**ADDENDUM NO. 4**

Invitation to Bid (ITB) No. 18-101031, South River Trail: Phase 5 (PI#0009029) is hereby amended as follows and all documents are incorporated herein by reference:

CONSTRUCTION PLANS OF PROPOSED  
SOUTH RIVER TRAIL, PHASE 5

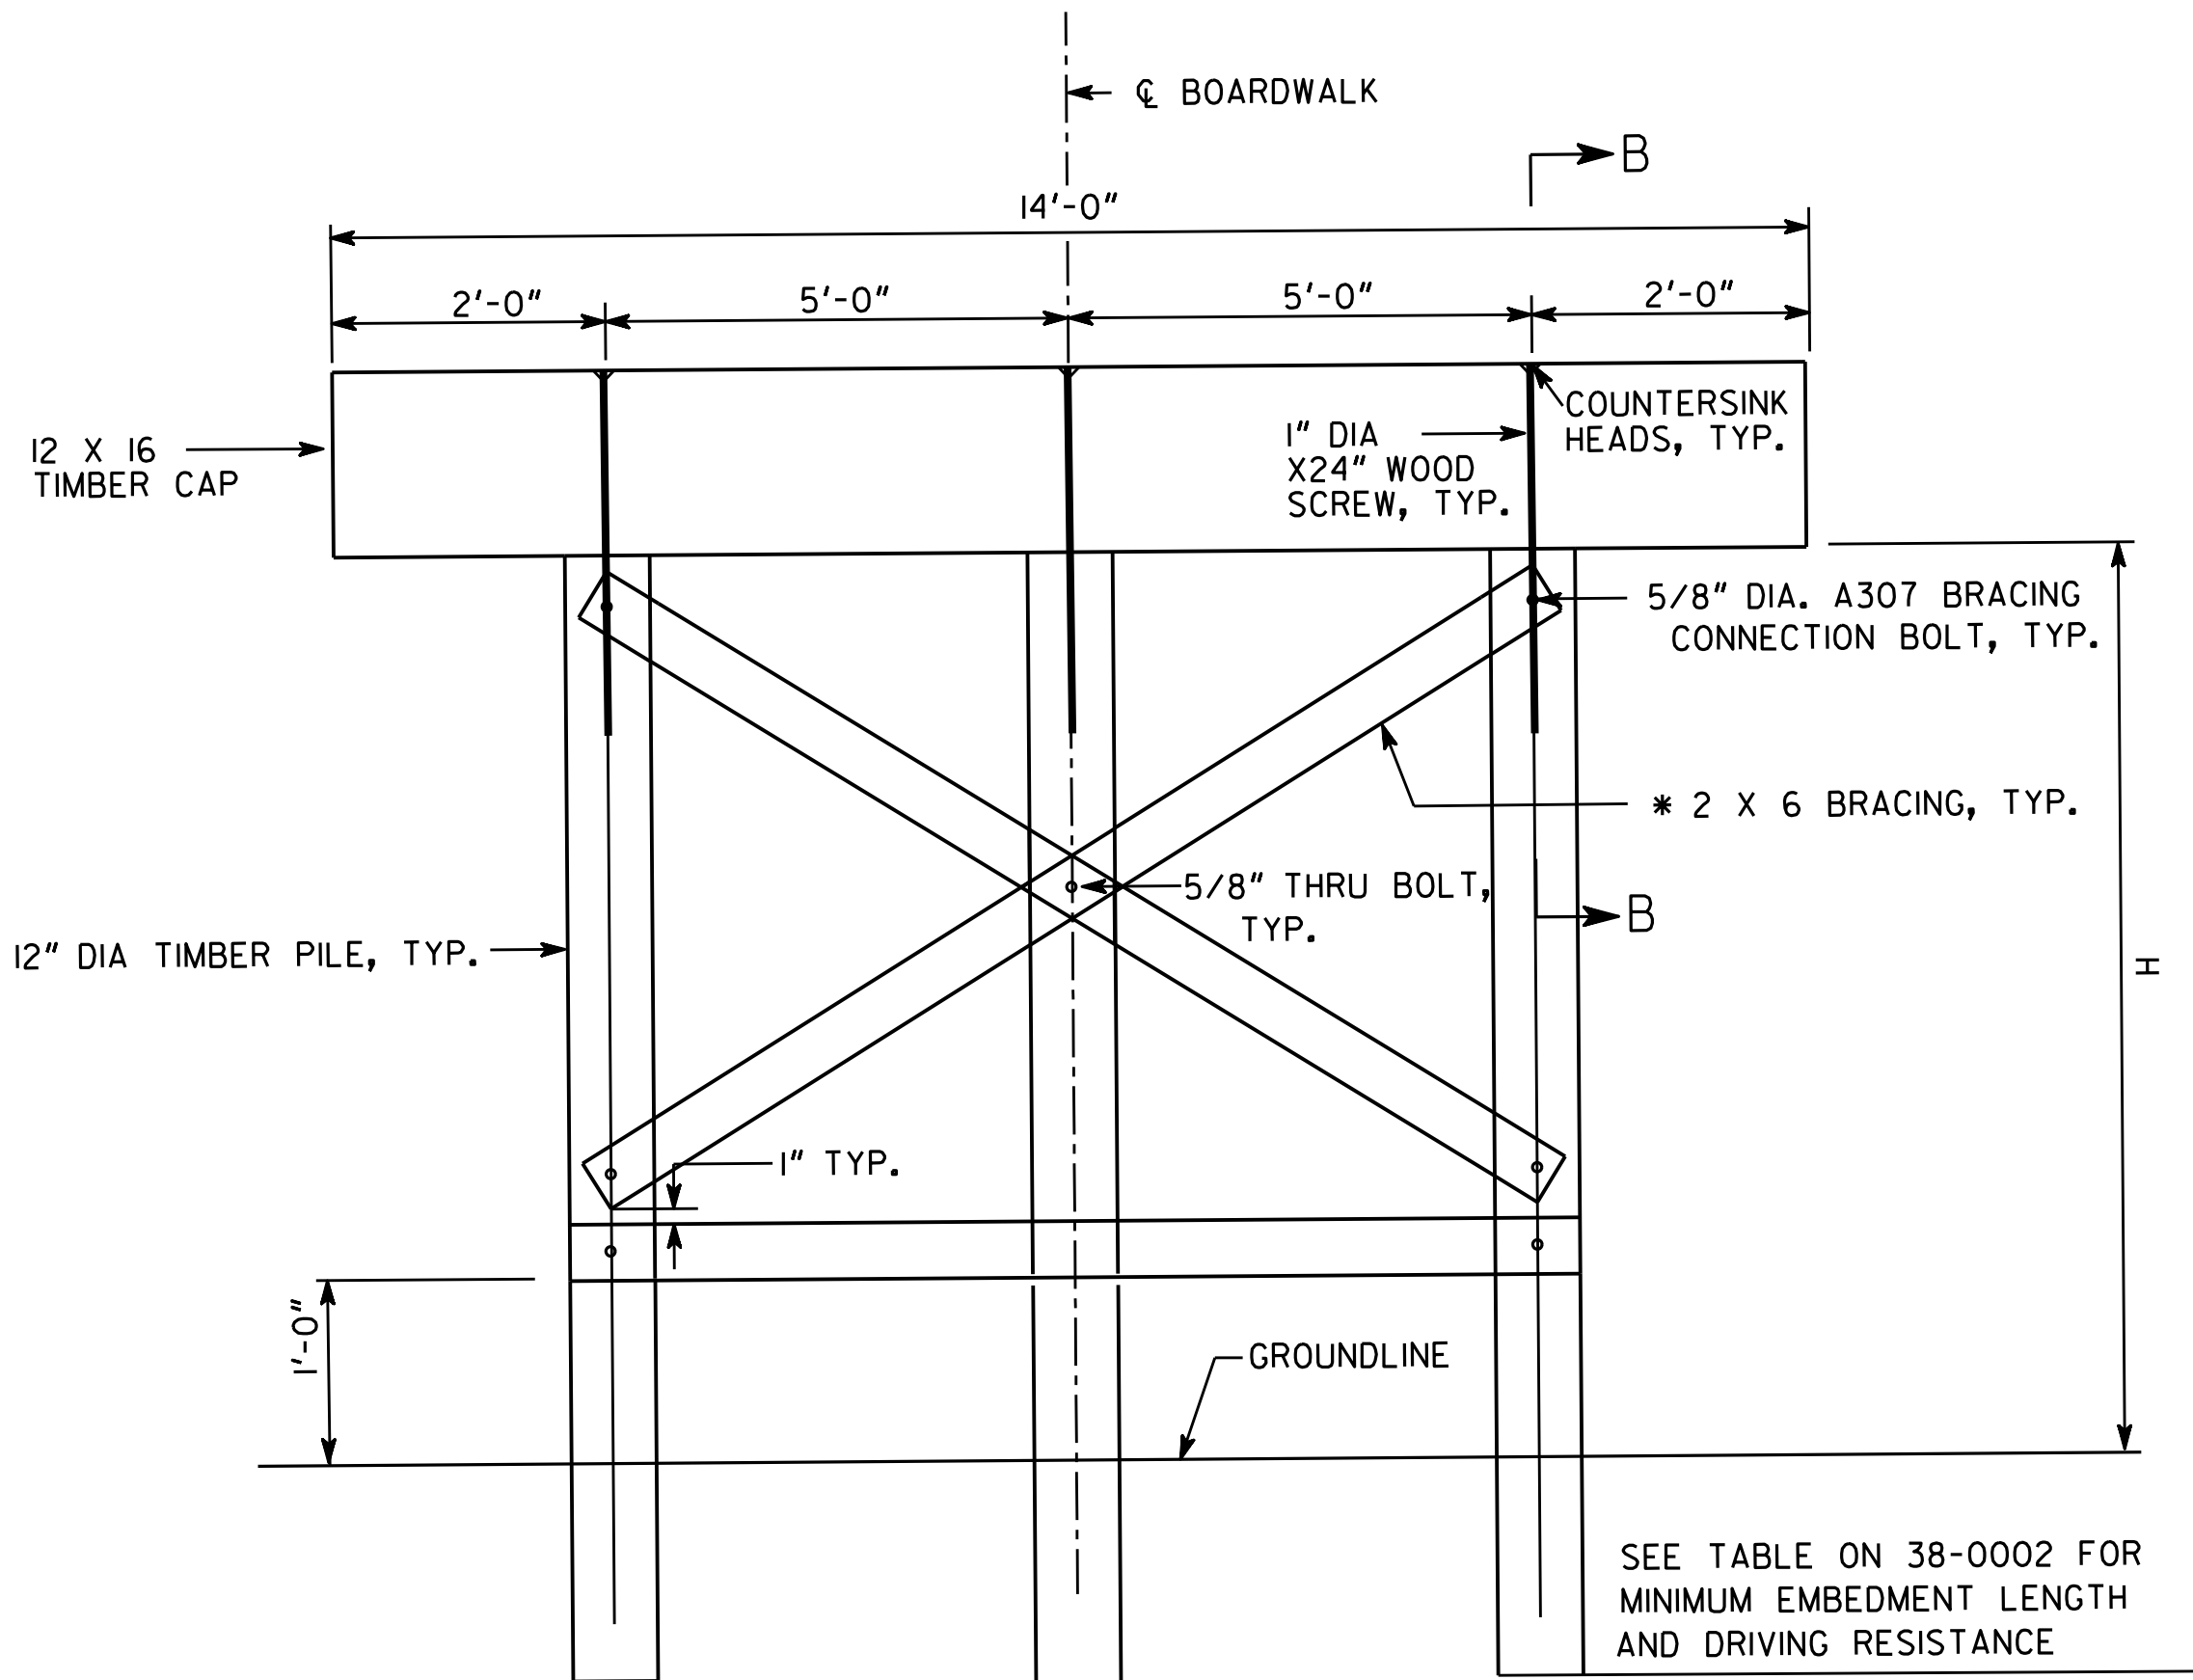
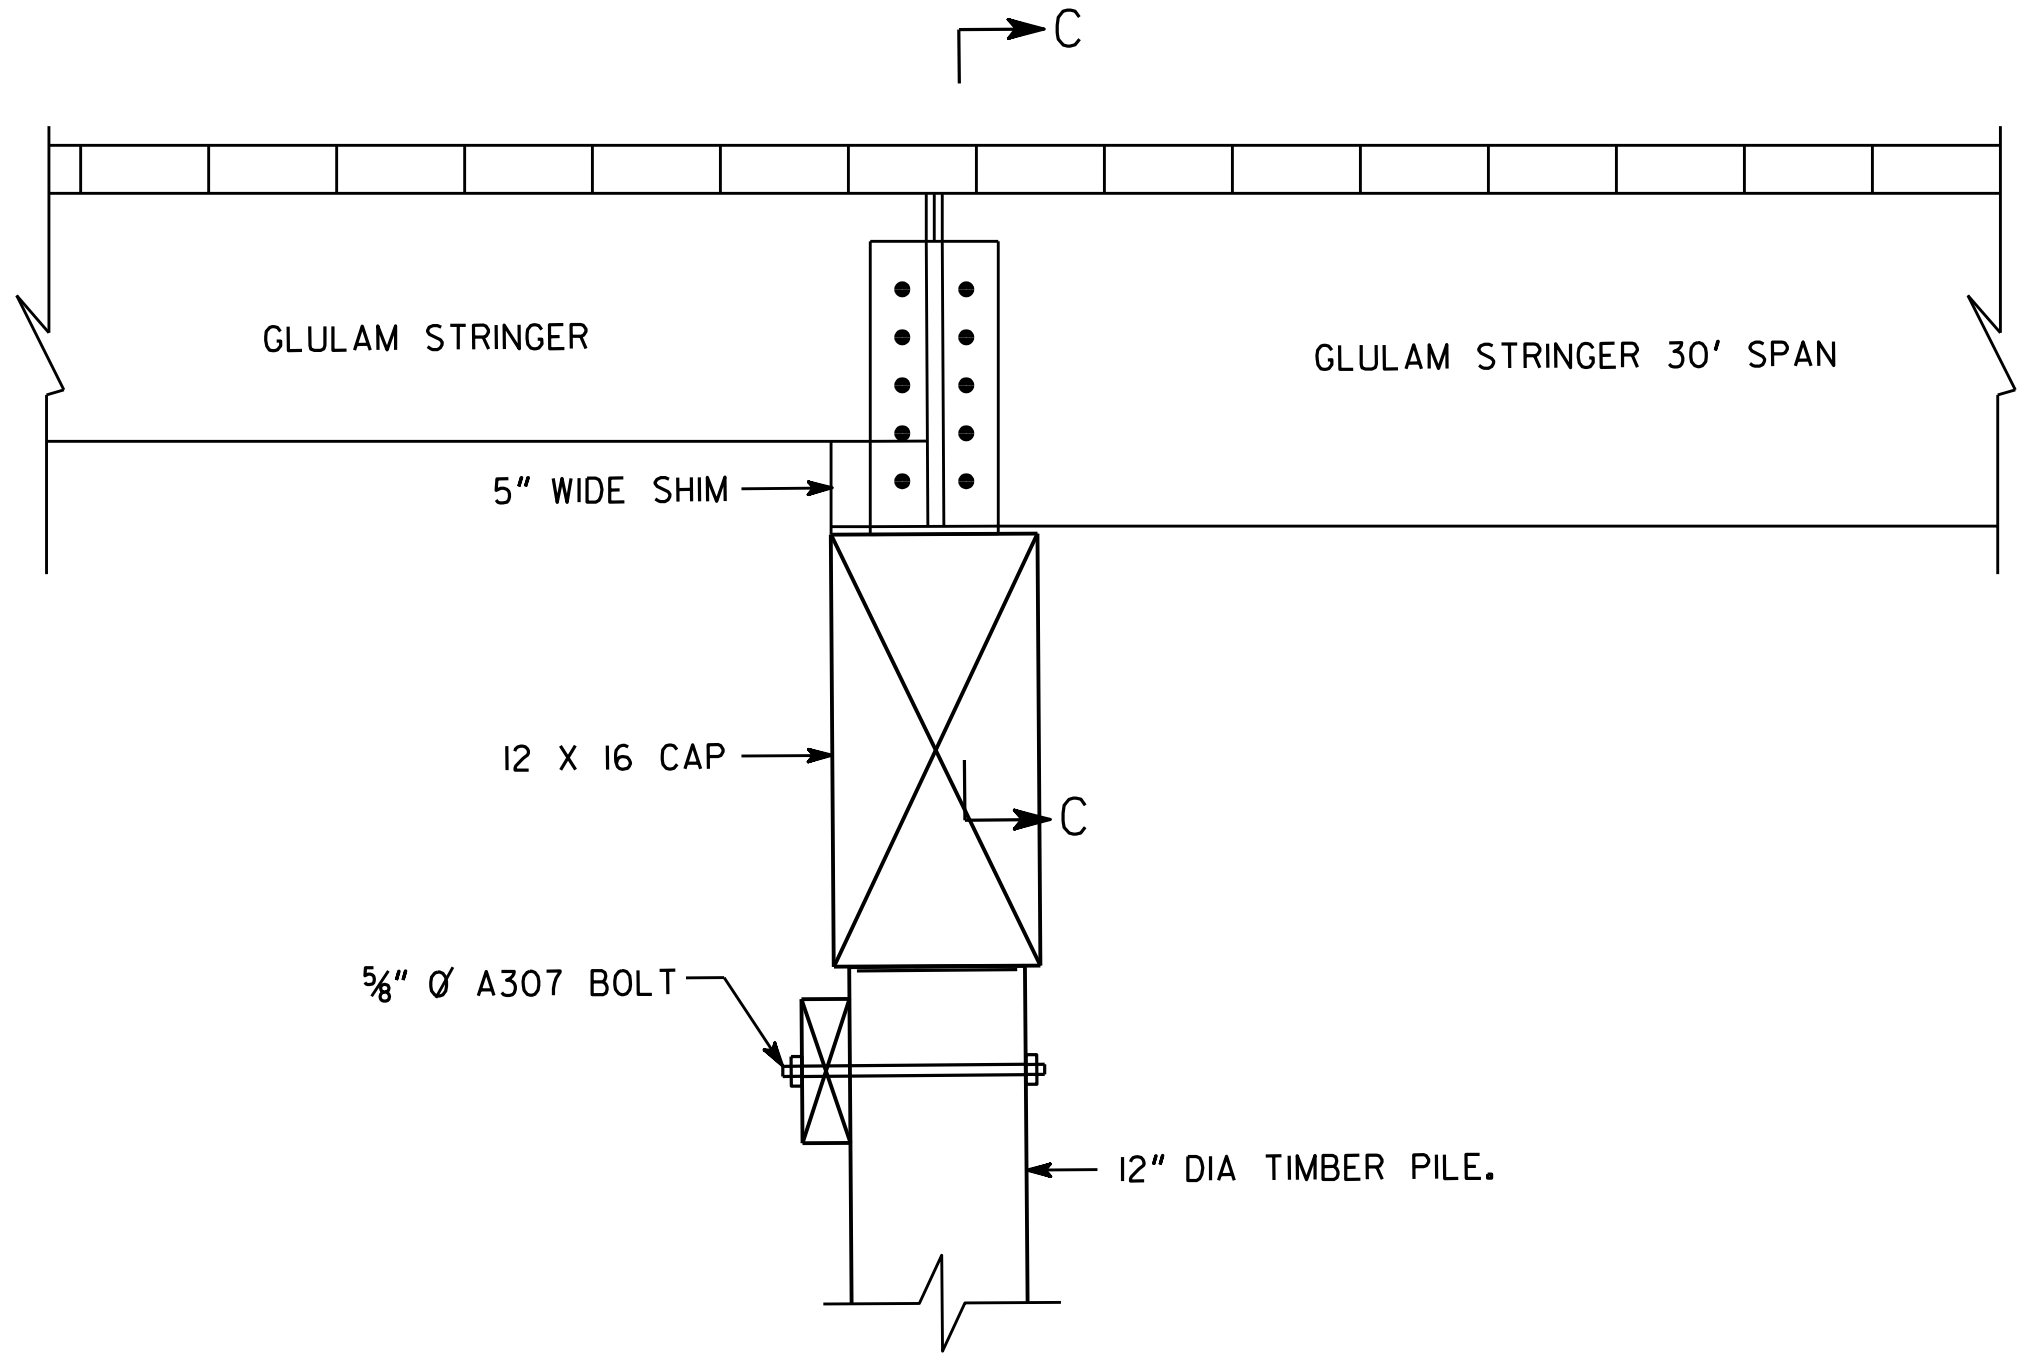
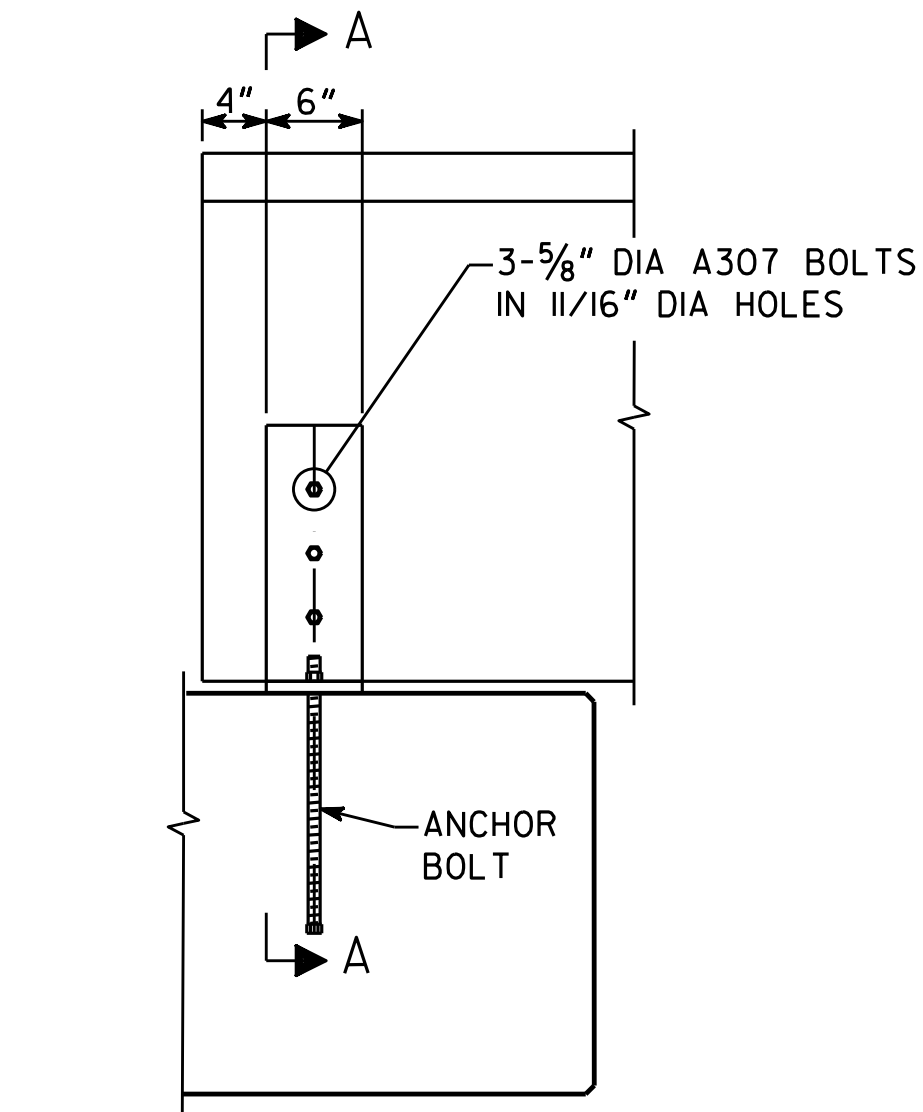
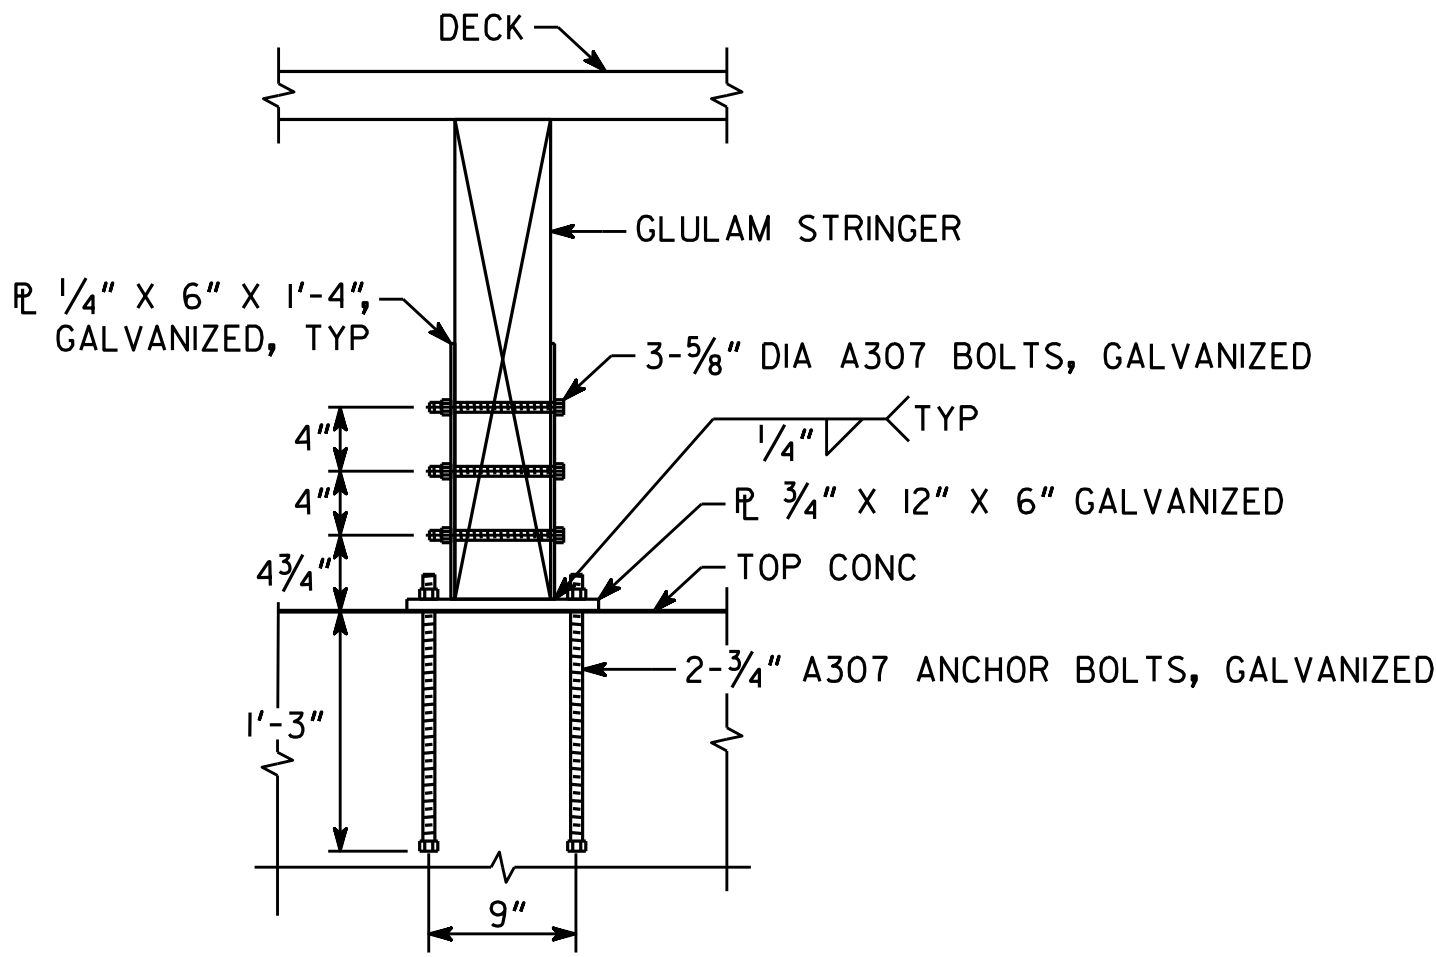
1. Drawings 01-0001, 03-0001 & 38-0004 are revised. The notes on the plan sheet (Drawing 38-0004) are revised to specifically include the cost of the Timber Treated Piling in the cost of the Boardwalk.
2. The County received the following questions pertaining to this ITB. The questions and resulting answers appear below:
  - A. Question: Regarding Pedestrian steel truss bridges, Drg. 35-0001 & 35-0004 mentioned "Pre-engineered Steel Bridge Truss **by others**" but there are line items 534-1000 for them. So can you clarify the general contractor's scope of work here? We understand bidder will not responsible steel bridge cost if steel fabricator will be provided and installed steel bridge than what cost bidder is responsible to cover for Item 534-1000. (Question is verbatim as received from Contractor)

D. Question: We are working on filling in the bid form and just noticed that the line item for the Timber Piles was removed. The original bid form had 8412 LF of PILING TIMBER TREATED. The Addendum 2 bid form does not have this item and the narrative does not mention removing it. Is the intent that the Timber Piles are to be included in the LF cost of the Boardwalk? Please advise.

Answer: The Timber Treated Piling is included in the LF price bid for the Boardwalk. Please refer to the revised plan sheet (Drawing 38-0004) and revised notes.

NOTE:  
502-1200 BOARDWALK (BRIDGE TIMBER, TREATED) LF, REFERS TO 4X14 AND 4X16 STRINGER SPANS NOTED IN THE STRINGER SELECTION TABLE ON 38-0002. PRICE BID PER LF SHALL INCLUDE ALL ITEMS NECESSARY TO CONSTRUCT BOARDWALK COMPLETE IN ACCORDANCE WITH THE DETAILS AND NOTES ON 38-0002, 38-0003, AND38-0004. PRICE BID PER LF SHALL ALSO INCLUDE TREATED TIMBER PILES AND REQUIRED PRE-DRILLING OF TIMBER PILES.

502-1500 BOARDWALK (BRIDGE TIMBER GLUED LAMINATED TREATED) LF, REFERS TO GLUED LAMINATED SPANS NOTED IN THE STRINGER SELECTION TABLE ON 38-0002. PRICE BID PER LF SHALL INCLUDE ALL ITEMS NECESSARY TO CONSTRUCT BOARDWALK COMPLETE IN ACCORDANCE WITH THE DETAILS AND NOTES ON 38-0002, 38-0003, AND38-0004. PRICE BID PER LF SHALL ALSO INCLUDE TREATED TIMBER PILES AND REQUIRED PRE-DRILLING OF TIMBER PILES.
